Motor Retainer Upgrade Notice

WART-HOG Kit

REVISED LOCATION GUIDE

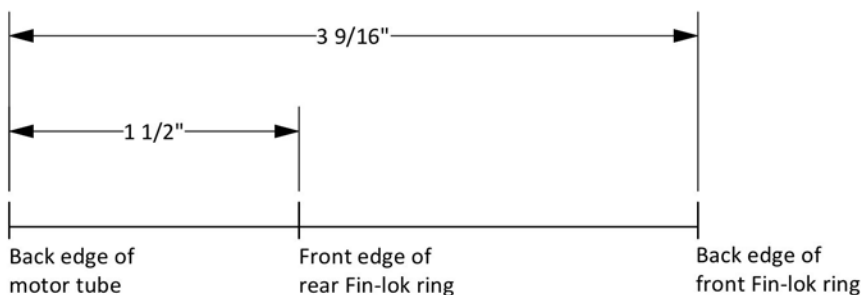
Use the **LOCATION GUIDE** above to make pencil marks along the motor tube line for location of the **FIN-LOK** rings per **STEP 3**. The new marks will move the motor tube rearward so that it is flush with the end of the body tube.

Follow Step 1 of **FIN-LOK ASSEMBLY** using new location marks as above.
